**PERMIT REPORT**

**To:** Board of Managers

**From:** Erin Manlick, Permitting Assistant

**Re:** Permit 19-110: The Blake School, 110 Blake Road South, Hopkins

**Figure 2 - 2014 Delineated Wetlands (2012 Photograph)**

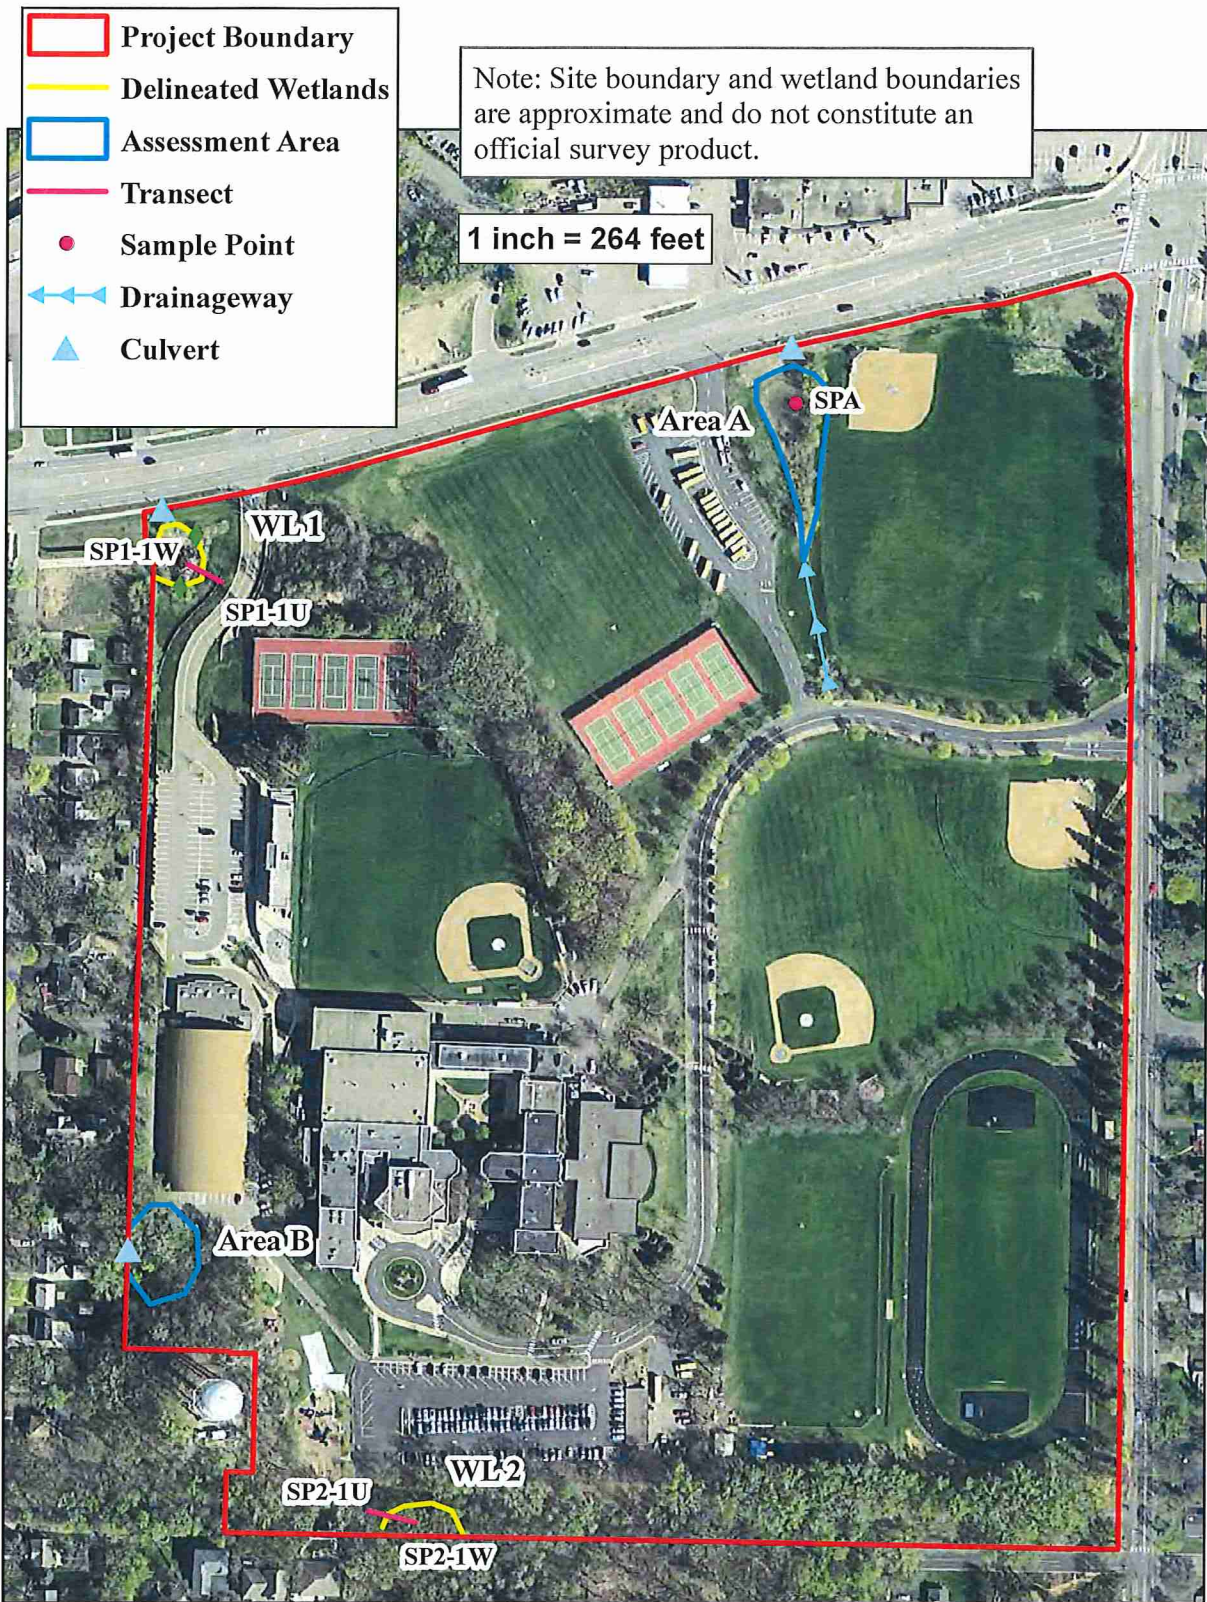
The wetland boundaries and types were delineated on October 9, 2014 and approved by the District on February 20, 2015 (see Attachment 3: Boundary and Type Notice of Decision). There are no proposed wetland impacts.

MCWD approves the wetland boundary as delineated in the field and documented in the delineation report (Figure 2). This decision is valid for five years. A future project located on this property may require a permit from the MCWD.

Sheet Title:	WETLAND BUFFER	Project #:	12146149.100
Project Title:	LOBBY ADDITION THE BLAKE SCHOOL	Attachment:	A1
Revision:		Issue Date:	06.05.19

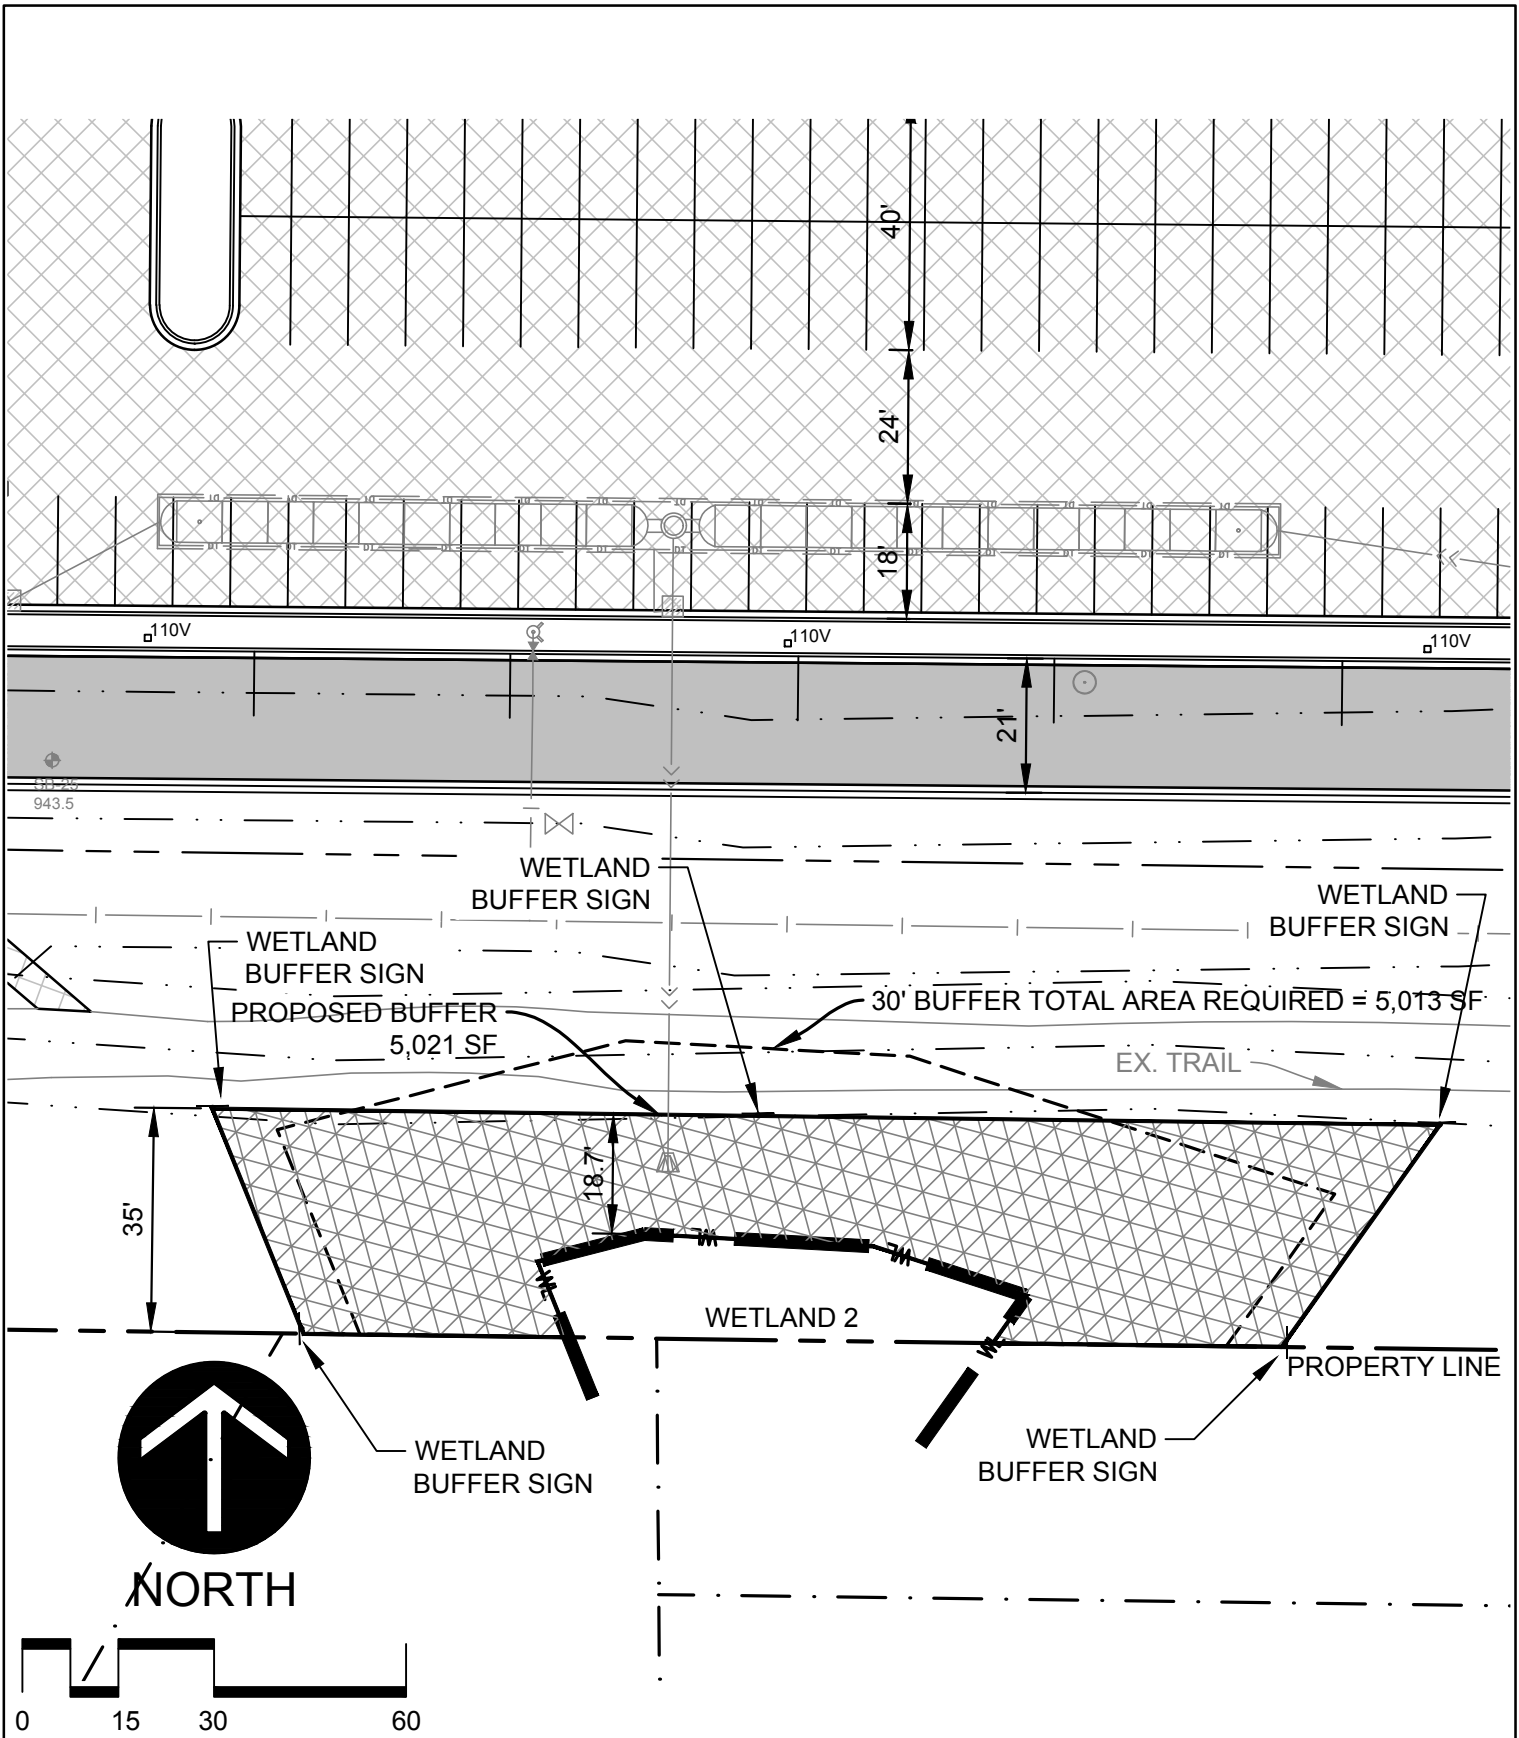
Per section 5(a) of the Wetland Protection rule, buffers must be provided around all disturbed wetlands and on wetland edges downgradient of disturbance. The applicant has provided plans demonstrating that buffers will be provided on all applicable wetland areas. Additional analysis on buffer width has been provided under section 6(c) below.

Section 5(d) of the rule requires a permanent wetland buffer monument to be installed at each lot line where it intersects the buffer, and where needed to indicate the contour of the buffer, with a maximum spacing of 100 feet. The applicant has provided a wetland buffer exhibit that demonstrates monumentation placed along the wetland buffer contour spaced no more than 100 feet apart and at each property line (Attachment 4).
